MEMORANDUM

SUBJECT: EPA Comments on "Assessment of Dam Safety of Coal Combustion Surface  
Impoundments: Luminant Generation Co., LLC – Oak Grove Steam Electric Station,  
Franklin, TX

DATE: April 7, 2014

# Dam Safety Assessment of CCW Impoundments

FIGURE 1

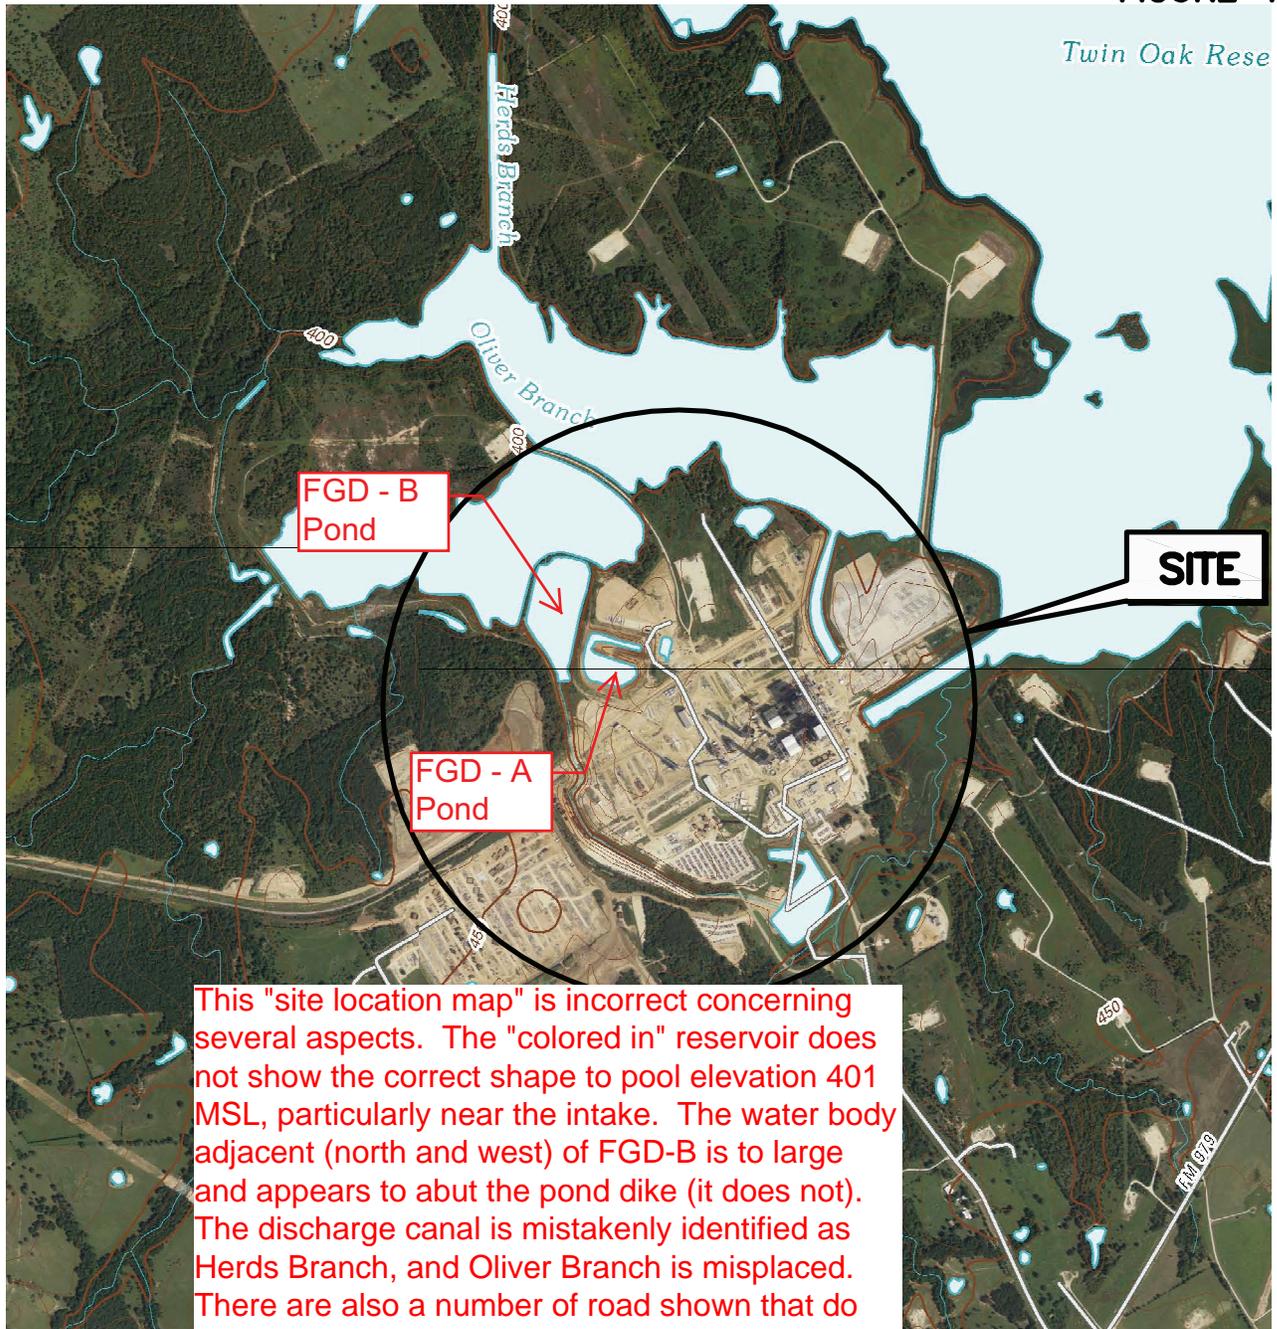
This should be updated with a more recent aerial.
